MEMO – Eric Li
March 17, 2026
Kaady Car Wash - West Linn – Environmental Water Quality Treatment
Page 2

From: Eric Li <ericl@tvaarchitects.com>
Sent: Wednesday, March 18, 2026 11:28 AM
To: Wendie Kellington; Wyss, Darren; Chuck Kaady
Subject: FW: Kaady Car Wash - Landscape Width Adjustment
Attachments: A0.01 Site Plan - CUP Supplemental.pdf

Subject: Kaady Car Wash - Landscape Width Adjustment

WEST LINN – KAADY CAR WASH

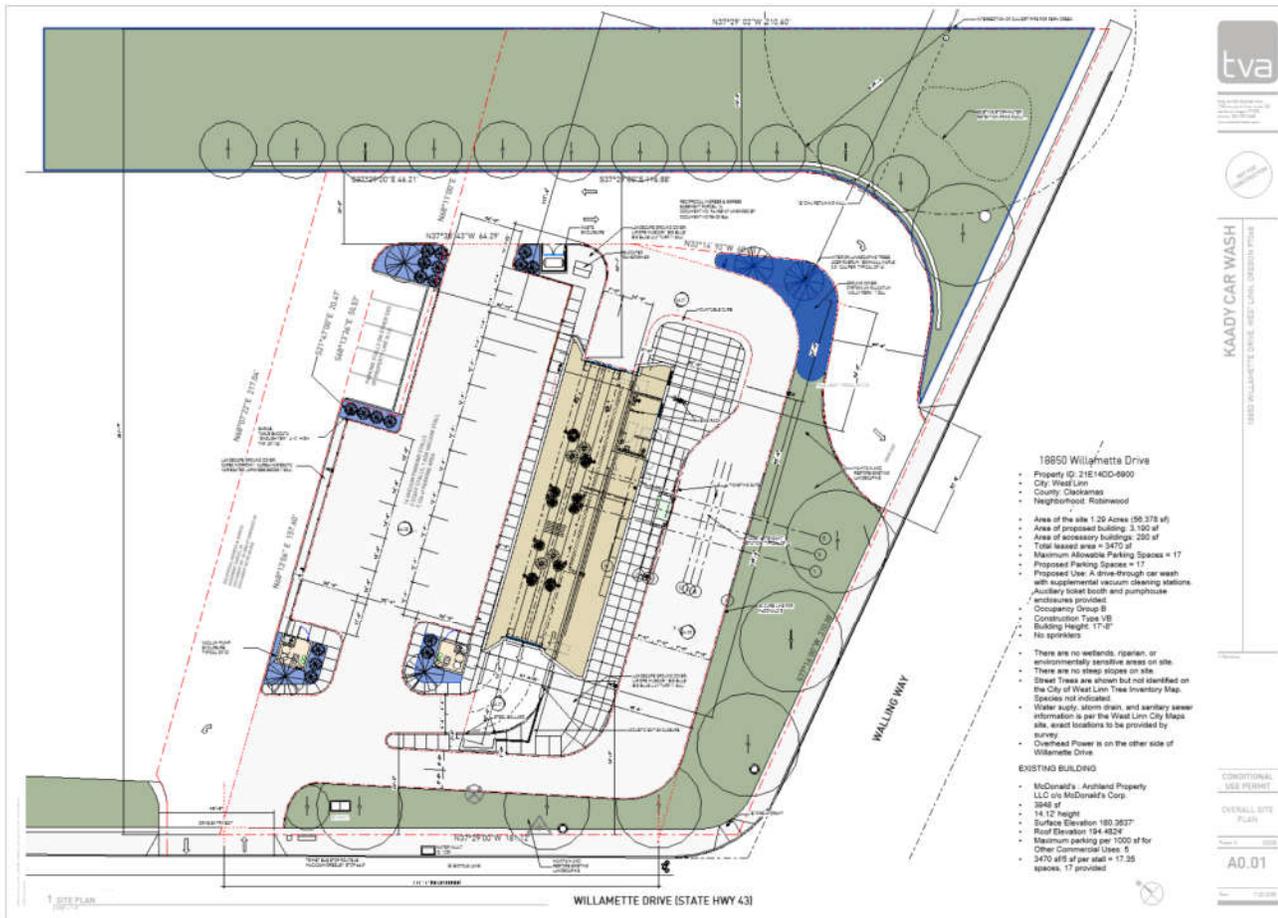
Per the zoning code we need to be 5sf of planting per 100 feet of vehicular use area. The vehicular use area is shown here in blue. 16,915 sf

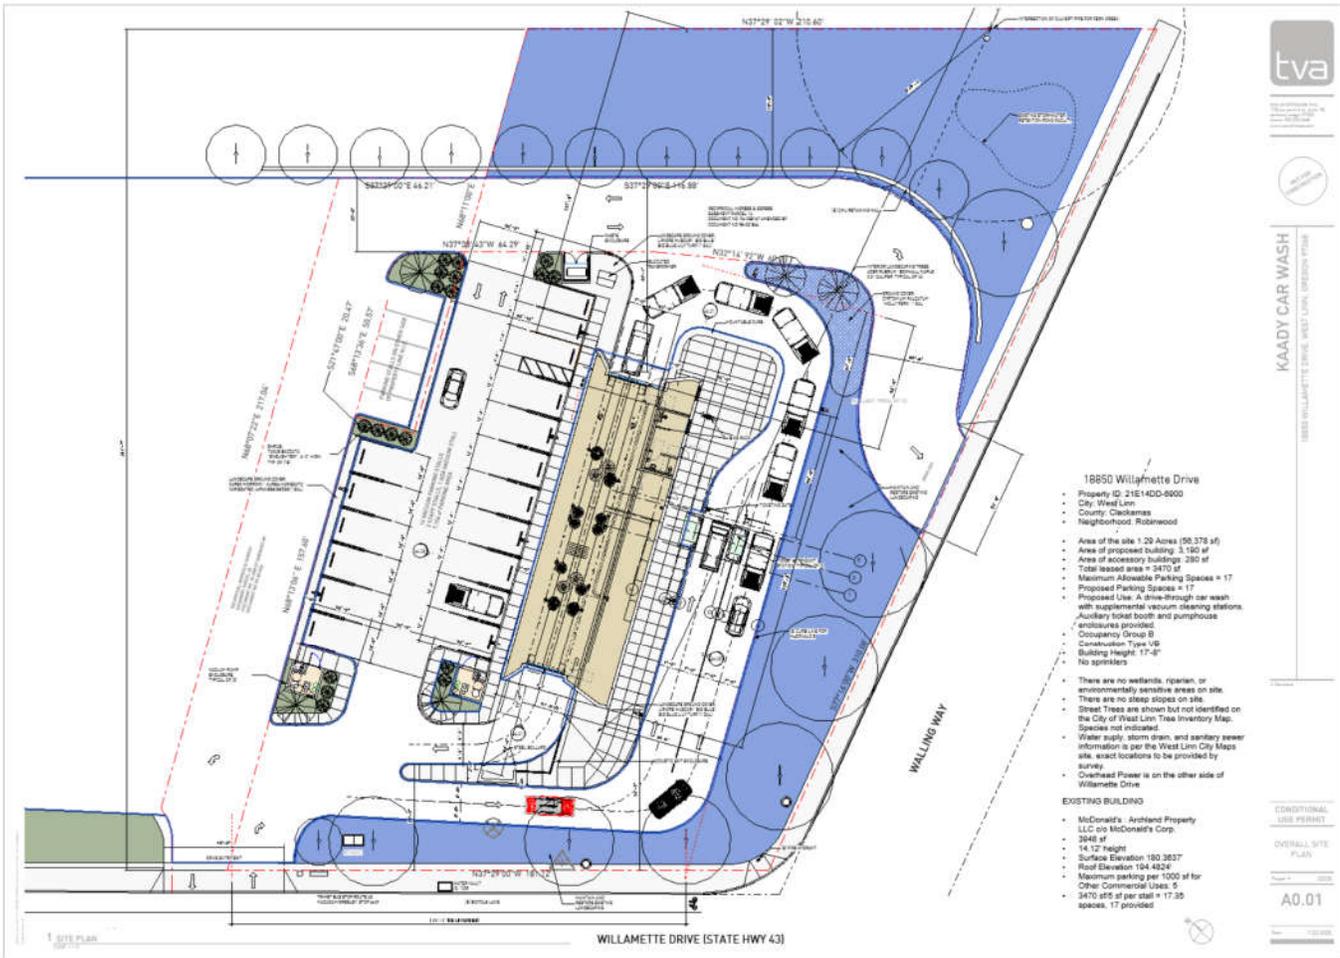
The interior planting areas are shown in this diagram, also in blue: 2500 sf

2500/16195 = 15.4% coverage. Compliant.

For the perimeter landscaping, you informed me that we needed 20% landscaping compared to the overall site.

Our perimeter landscaping is 19,064 sf. Our project site is 56,378 sf. 19,065/56,378 is 33.8%. Compliant, and then some.

A0.01

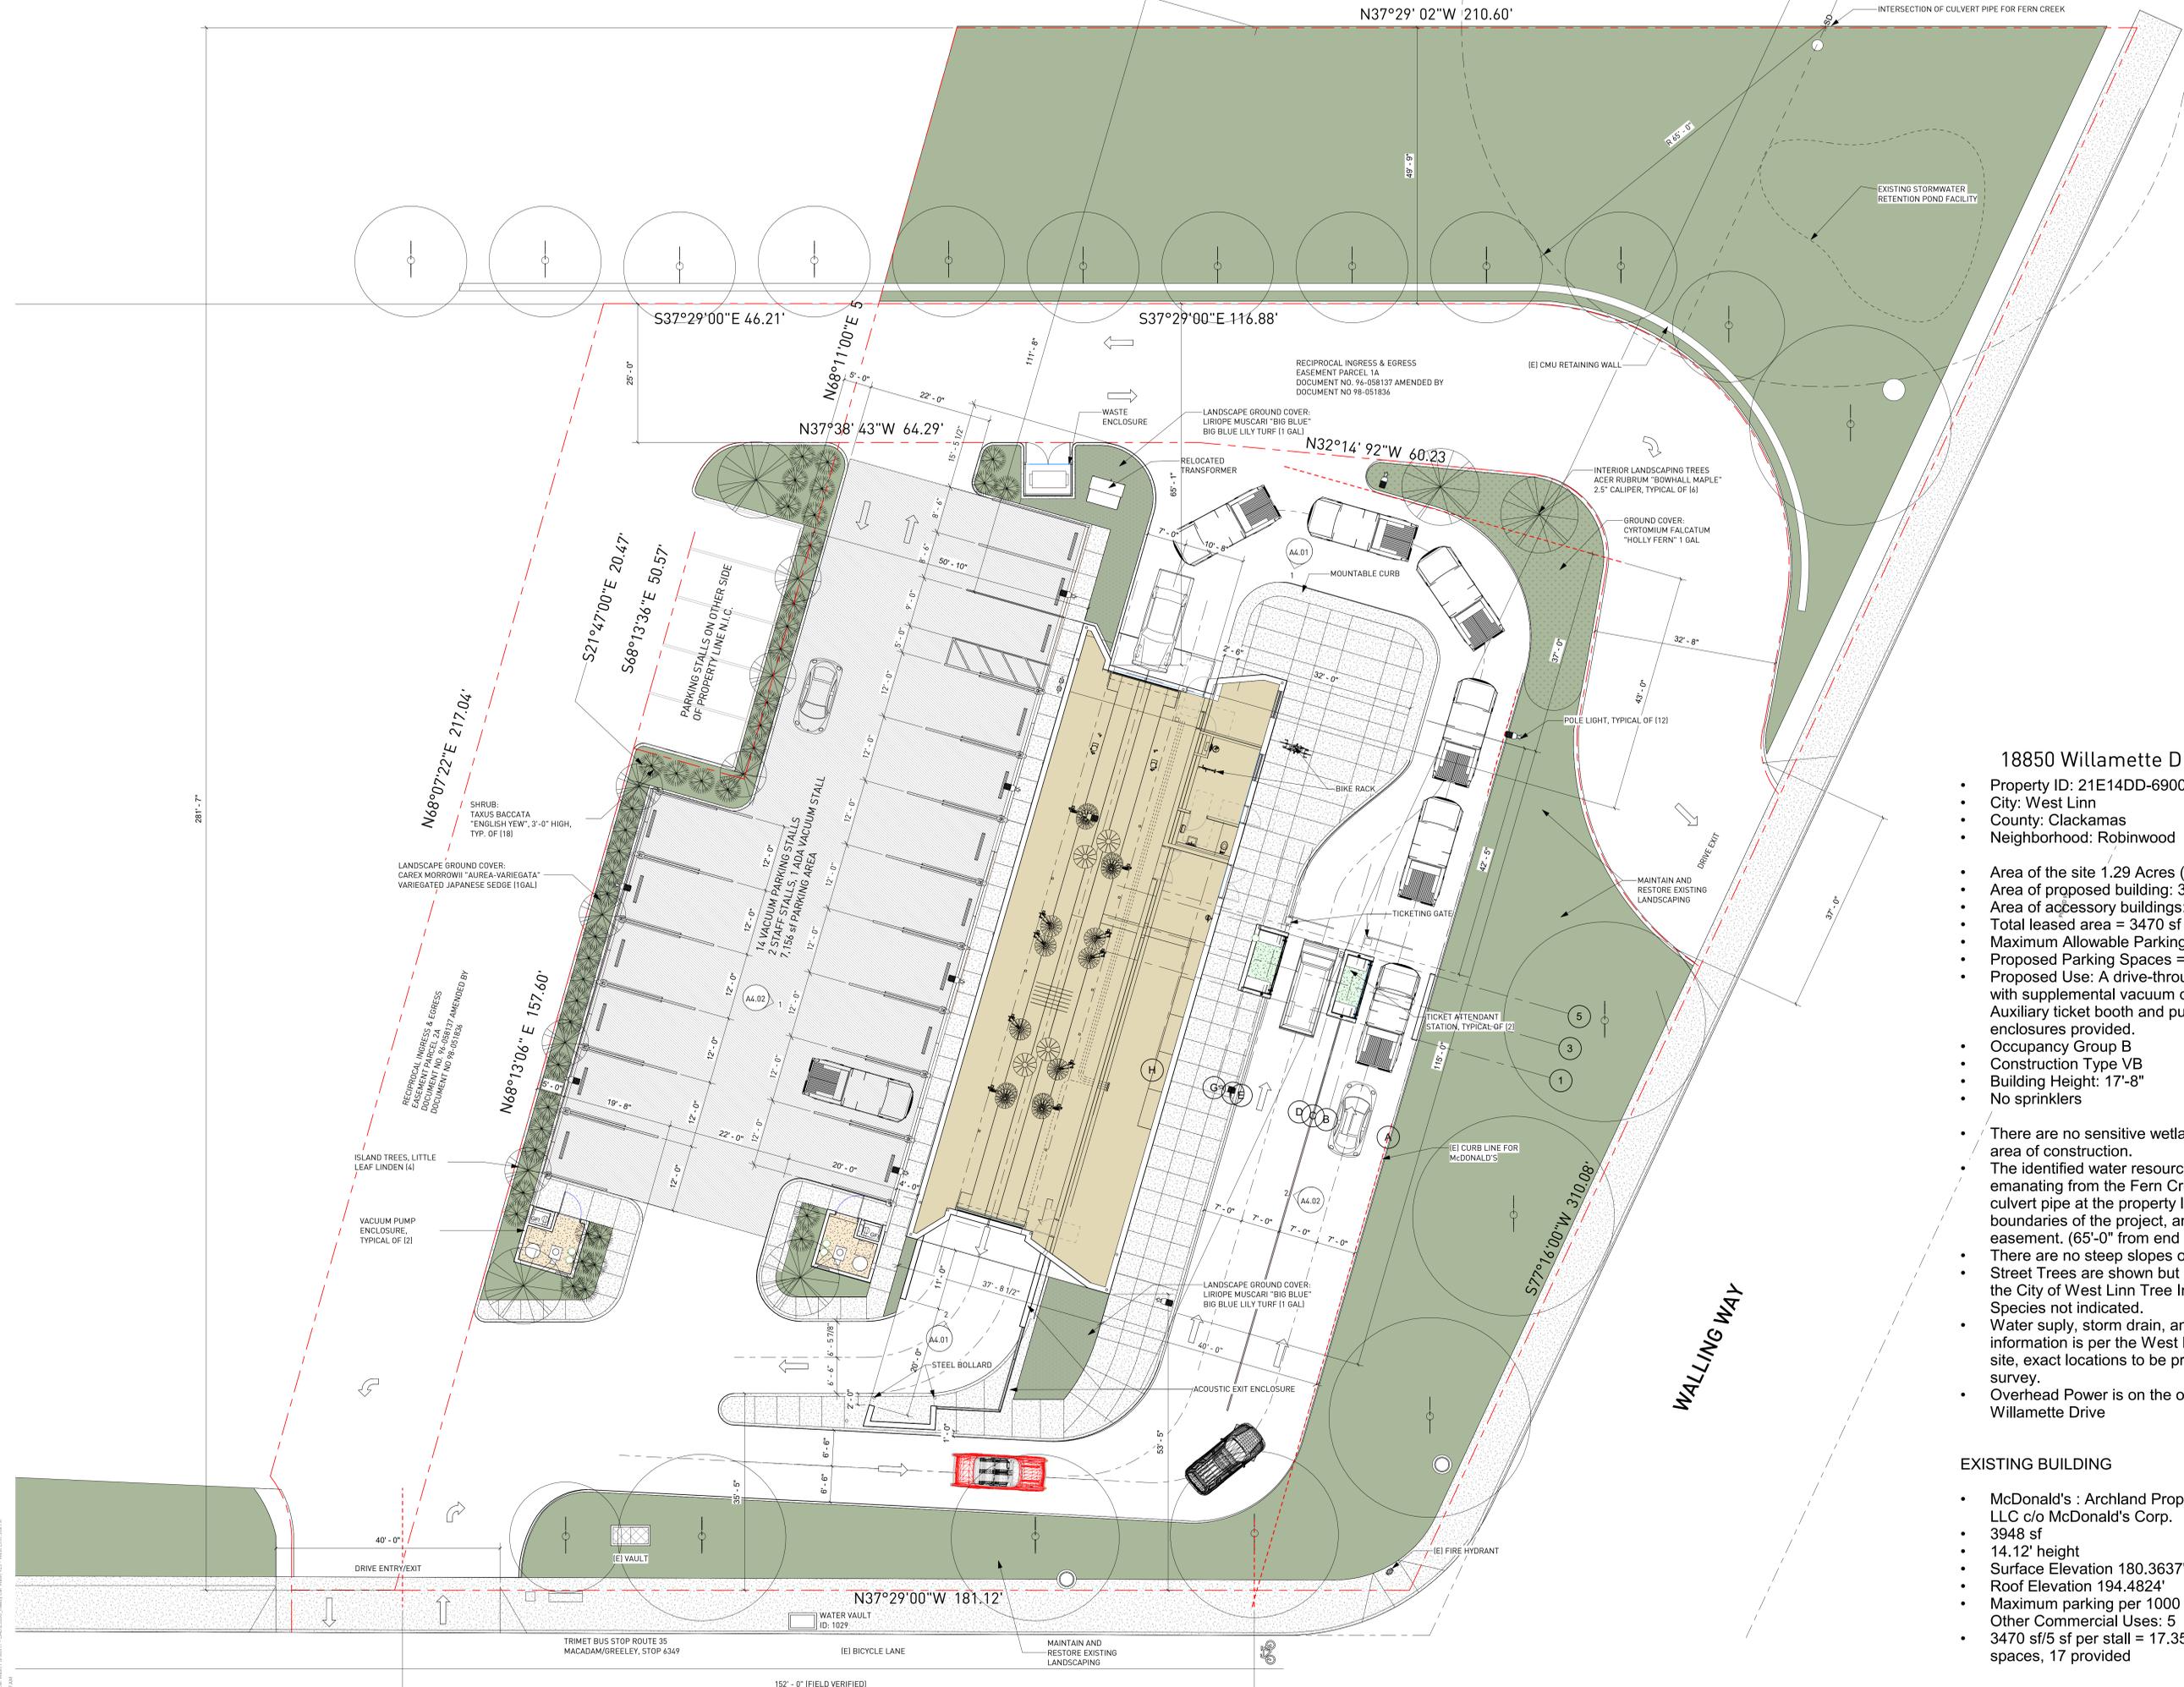
The parking island between the vacuum stations and the property line/mall parking lot has been widened from 3.9' to 5'-0" width, compliant with the Municipal Parking Code. The walkway adjacent to the car wash has been reduced from 5'-0" in width to 4'-0", and the north parking stalls have been reduced from 20'-0" in depth to 19'-8" to accommodate this change.

Rather than trying to get a discretionary approval or appeal for the width of the parking island, we have modified the island to increase from 3'-9" to 5'-0" in width. The allowable sidewalk width in West Linn is 4'-0", so we narrowed the sidewalk adjacent to the building from 5'-0" to 4'-0". The minimum depth of parking stalls is 18'-0", so we reduced the north parking stall depth on the north side from 20'-0" to 19'-8" which got us the outright permissible dimension for the parking island.

- Trees spaced as appropriate to the species not to exceed 30 feet apart on center, on the average. (7 X Little Leaf Linden @ 24'-0" o.c.)
- Shrubs, not to reach a height greater than 3'-0" (Pacific Yew)
- Vegetative ground cover, to cover 100 percent of the exposed ground within two growing season. No bark mulch shall be allowed except under the canopy of low-level shrubs. (Variegated Japanese Sedge)
